WURLITZER

Organ Notes

FREQUENCY RESPONSE - MODEL 500 TONE CABINET

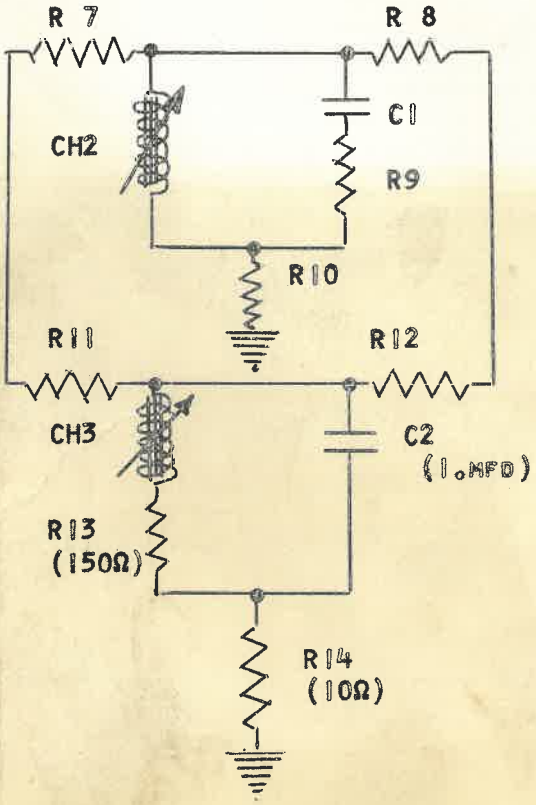
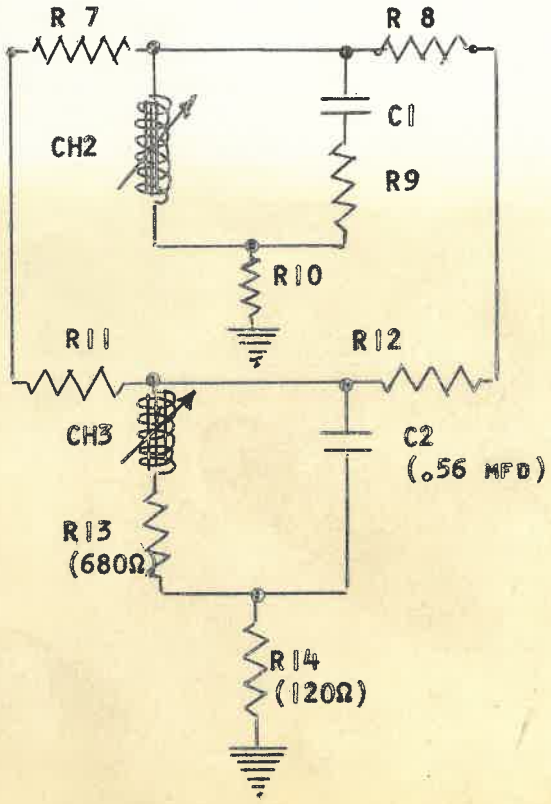
UNDER CERTAIN ACOUSTICAL CONDITIONS, A LACK OF PROPER RESPONSE MAY BE NOTED ON MODEL 500 TONE CABINETS BELOW SERIAL # 393501. THE FREQUENCY RESPONSE CAN BE ALTERED BY CHANGING THREE COMPONENTS IN THE AMPLIFIER AS SHOWN ON THE SCHEMATIC DIAGRAMS BELOW.

1 EACH- 120Ω, ½ WATT RESISTOR
1 EACH- 680Ω, ½ WATT RESISTOR
1 EACH- .56 MFD., 100 VOLT CAPACITOR

BEFORE CHANGE

AFTER CHANGE
